## QUALITY ASSURANCE -- NON-CONFORMANCE REPORT

**Report No:** NCR-000679

**Reference Description:** ZPMC performed a non-approved tack welding of scaffolding to the OBG Segment 7DW Side Panel

**Job Name:** SAS Superstructure  
**Document No:** 05.03.06-000636

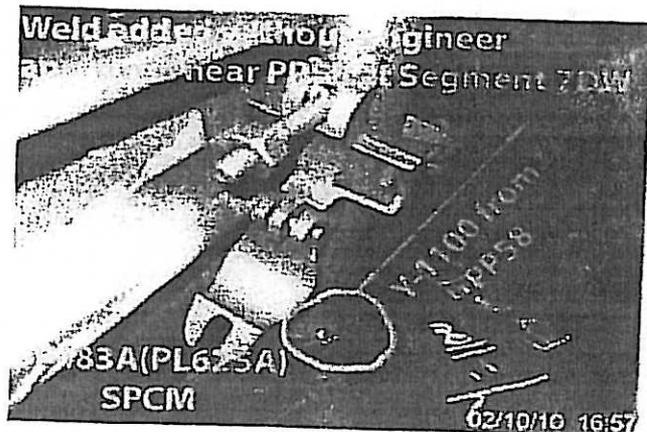
During the Quality Assurance (QA) random visual inspection after grit blast inside Orthotropic Box Girder (OBG) segment 7DW, this Quality Assurance Inspector (QA) discovered the following issues:  
-ZPMC has temporarily tack welded 2 scaffolding legs to a Seismic Performance Critical Member (see pictures for reference).

- The approved shop drawings do not specify any welds in these areas.
- The size and length of the tack welds do not meet the requirements of AWS D1.5 2002, table 12.2.
- The member is a side panel identified as: SP483A.
- The Side panel is designated on the approved shop drawings as (SPCM).
- The Side panel is located between panel point PP057 and PP058 on the Cross Beam side.
- The location of the temporary tack welds are 340mm and 1100mm from PP058.
- The material composition of the scaffolding being welded to the side panel is not known.
- OBG Segment 7DW is located inside the Blast Shop.

**Draft of welding discontinuity:**

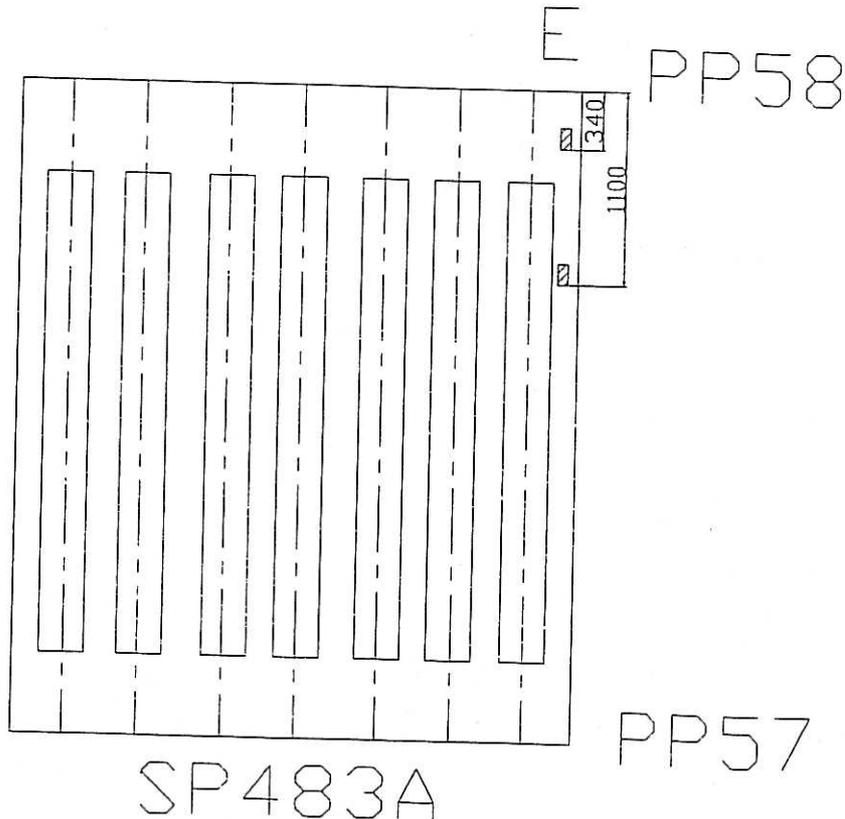
经检查发现7DW箱梁斜底板SP483A与箱体内脚手架钢管的接触点处有2个点焊, 现要求将不合格点焊去除后, 重新返修。具体位置见下图!

There are two unacceptable tack welds between SP483A and the bracket of scaffold in segment 7DW, which need to be removed and repair again.

1. 采用打磨的方法将上述点焊处的未知母材完全去除, 并将要修补的区域打磨光滑;
2. 返修前做100%VT和MT确保没有缺陷存在;
3. 根据返修的焊接返修工艺规程(WPS)进行预热及焊接;
4. 返修后将焊缝打磨至与母材平齐;
5. 根据图纸要求进行相应的NDT检测;

1. Remove the repair area including unknown base metal mentioned above away by the way of grinding, and grind the repair area cleanly;
2. Perform 100%VT and MT to the repair area to make sure no defects exist;
3. Preheat and weld according to the relevant WPS;
4. Grind the welds to flush with the adjacent base metal;
5. Perform relevant NDT inspection to the repair welds according to the working drawings.
